**PLANNING COMMISSION REPORT  
REGULAR AGENDA --NON-PUBLIC HEARING ITEM  
PUBLIC HEARING – VARIANCE ONLY**

**ITEM NO. 1: PRELIMINARY PLAT; DAN & TRISHA SIMONS ADDITION; 444 COUNTRY CLUB TERR (MKM)**

**PP-10-10-11:** Consider a 1 lot Preliminary Plat for Dan & Trisha Simons Addition, approximately 2.36 acres, located at 444 Country Club Terrace and associated variance from requirement in Section 20-810(b) that all lots have frontage on a public street. Submitted by Treanor Architects, PA for Dan & Trisha Simons, property owners of record.

**Figure 2.** Narrow strip of land owned by LCC separating the subject property from Country Club Terrace Right-of-Way shown in red.

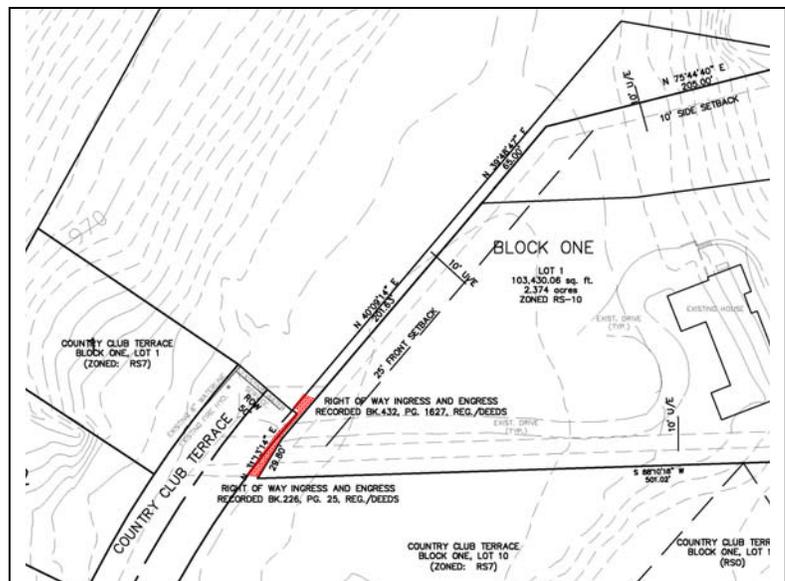
The subject property is located east of Country Club Terrace, and takes access from Country Club Terrace through ingress/egress right-of-way easements. The property does not have street frontage due to the dedication of Country Club Terrace right-of-way with earlier plats that ended within property owned by Lawrence Country Club rather than extending to the next property line (Figure 2).

As street frontage is required by the Subdivision Design Standards and none is provided for the new lot, a variance from the Planning Commission is necessary for the approval of this plat. The variance is discussed later in this report.

Staff recommends approval of the variance requested from Section 20-810(b) to allow the creation of a lot without street frontage.

**Figure 3.** GIS map showing the location of the right-of-way, right-of-way easements, and property lines. The colored properties are platted, with each color being a different plat.

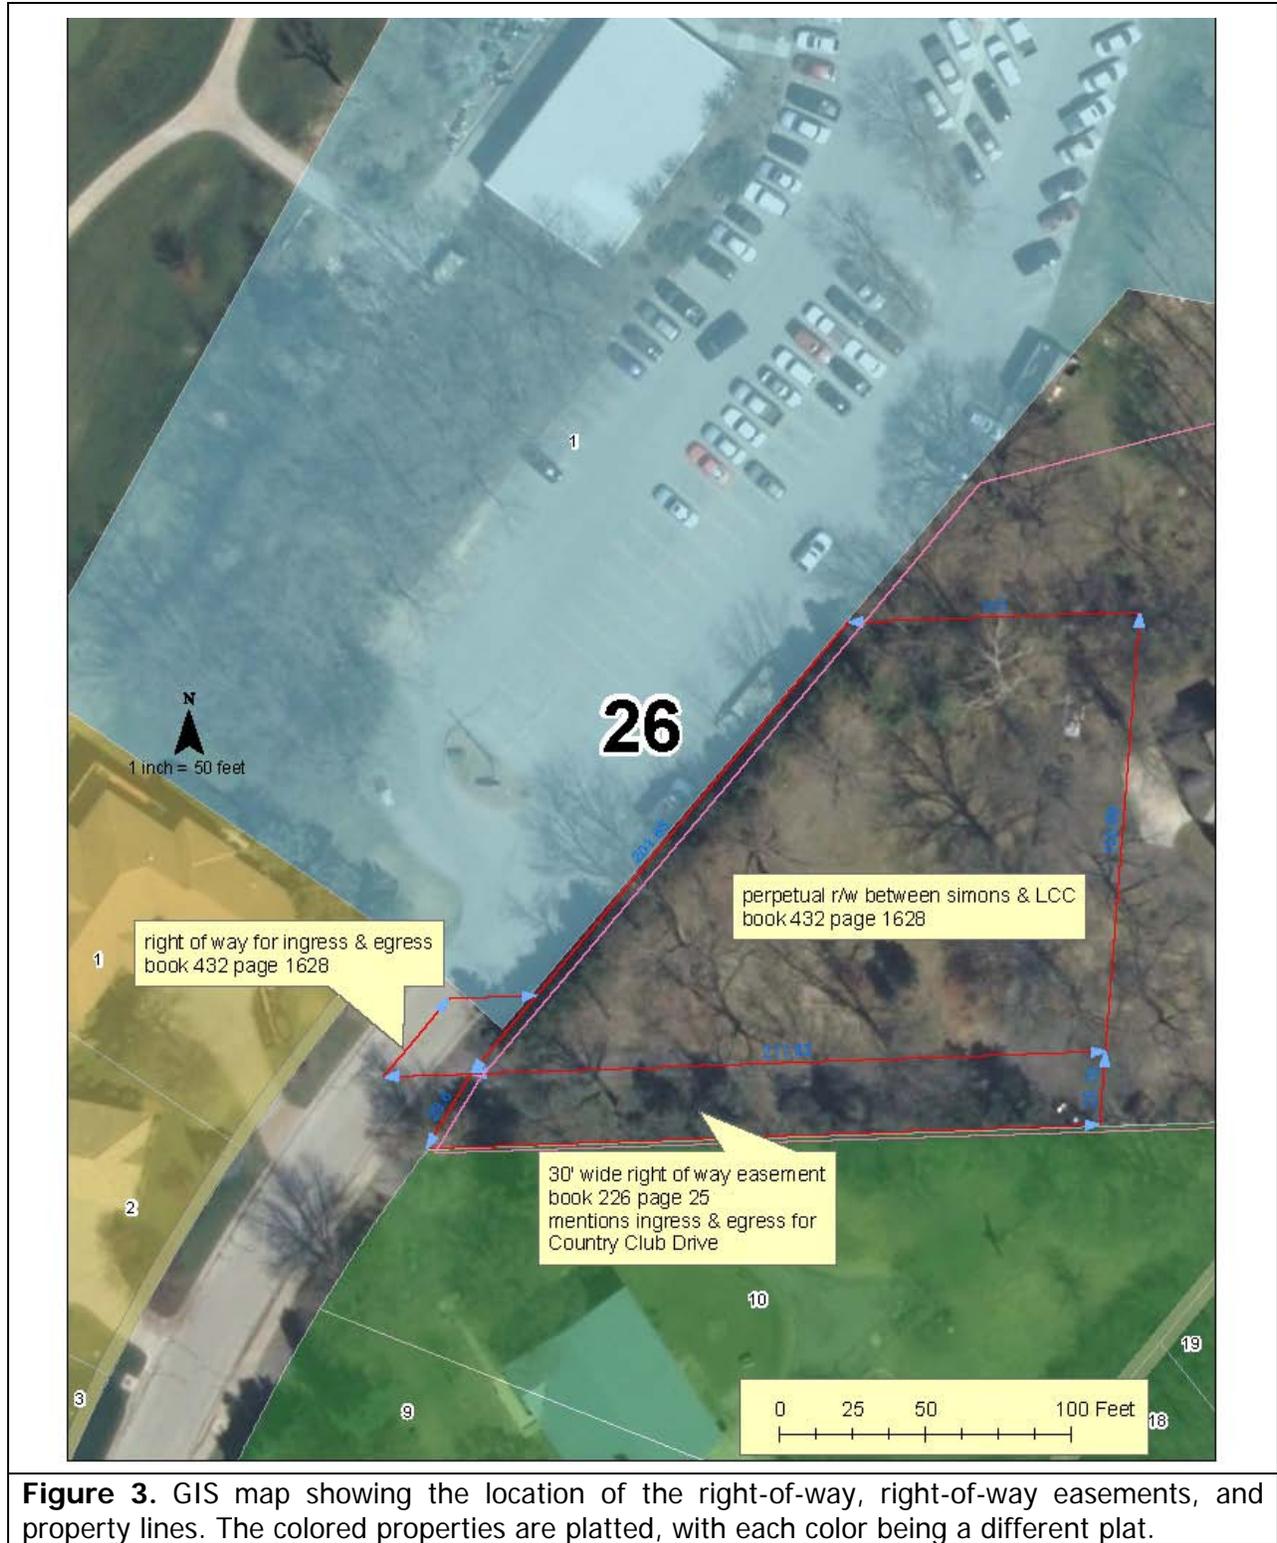
The house on the subject property was constructed in the 1960s and ingress/egress right-of-way easements were dedicated in 1963 and 1989 to allow the property access to Country Club

Terrace. When the right-of-way for Country Club Terrace was dedicated it did not extend to the property to the east; therefore, a narrow strip of land (approximately 5 ft wide) belonging to the Lawrence Country Club is located between the subject property and the street right-of-way. Due to this, the property has no actual frontage on the street. It is not possible for the property owners to provide frontage, as the strip of property is not owned by them and is not under their control. In staff's opinion, the easements that allow access from the subject property to the right-of-way are an acceptable alternative to actually securing and providing the right-of-way. As the subject property was developed with a residence in the 1960s, right-of-way easements for ingress/easement have been recorded to permit access to Country Club Terrace, prohibiting the plat based on this unique frontage situation would be an unnecessary hardship. Figure 3 shows the right-of-way access easements and right-of-way lines.
